Access Compliance Report Public Rights-of-Way (Curb Ramps)

Main Street: EDDY_DR		Cross Street: LORETTA_DR		Location:	NW
ADA ID: RPAT210930100055	Ramp Type:Type 1 - Perpendicular Diagonal Initial Pass/Fail: Fail		Overall Compliance: No	Severity Score:	2

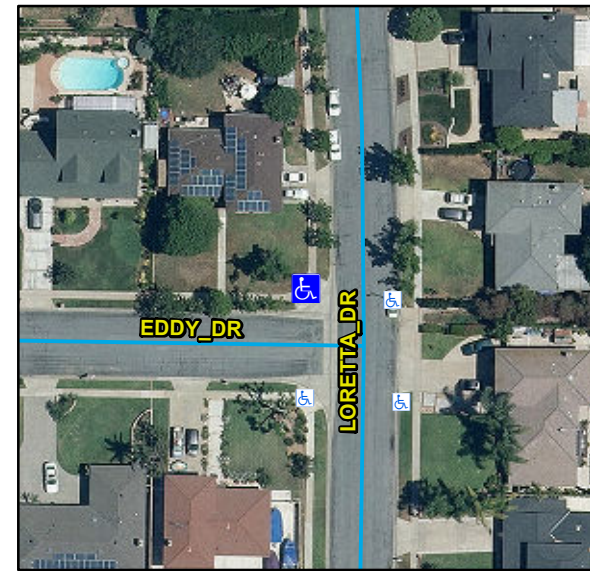
Compliance	Description	Data	Compliance	Description	Data
N/A	Ramp Length (in)	125	N/A	Flare Type LT	
Yes	Ramp Width (in)	58			N/A
Yes	Ramp Run Slope (%)	6.9	N/A	Flare Slope LT (%)	N/A
No	Ramp Cross Slope (%)	3.1	N/A	Flare Traversable LT	N/A
N/A	Landing Present	N/A	N/A	Flare Type RT	
N/A	Landing Length (in)	N/A			N/A
N/A	Landing Width (in)	N/A	N/A	Flare Slope RT (%)	N/A
N/A	Landing Run Slope (%)	N/A	N/A	Flare Traversable RT	N/A
N/A	Landing Cross Slope (%)	N/A	N/A	DWS Provided	N/A
N/A	Landing Movement Obstructed?	N/A	N/A	DWS Contrast	N/A
	Landing Movement Type	N/A	N/A	DWS Length (in)	N/A
N/A	Landing Shared	N/A	N/A	DWS Full Width	N/A
N/A	Clear Space	Yes	N/A	DWS Offset Left (in)	N/A
N/A	Clear Space To Crosswalk (in)	N/A	N/A	DWS Offset Right (in)	N/A
N/A	Marked Crosswalk 1	No	N/A	Marked Crosswalk 2	No
	Crossing 1 Direction	S		Crossing 2 Direction	E
	Marked Crosswalk 1 Width (in)	N/A		Marked Crosswalk 2 Width (in)	N/A

N/A	Ramp Inside Crosswalk 1	N/A	Yes	Ramp Inside Crosswalk 2	N/A
	Crossing 1 Slope (%)	1		Crossing 2 Slope (%)	4.9
	Crossing 1 Cross Slope (%)	3		Crossing 2 Cross Slope (%)	2.4
N/A	Gutter Ponding	N/A	No	Curb Slope	8.1
Yes	Gutter Lip Height (in)	0		Road Run Slope (%)	1.4
N/A	Gutter Run Slope (%)	N/A		Road Cross Slope (%)	4.1
N/A	Gutter Cross Slope (%)	N/A			
Yes	Overall Surface Condition: Acceptable		Yes	Perp Joint Present	Yes
	Cross Gutter Present?	Yes		Spandrel Present?	Yes
	Replace Cross Gutter?	No		Replace Spandrel?	No

Remove & Replace Curb Ramp With Two New Directional Ramps or Equivalent.

R304.2.2, R304.5.3, STD 1115
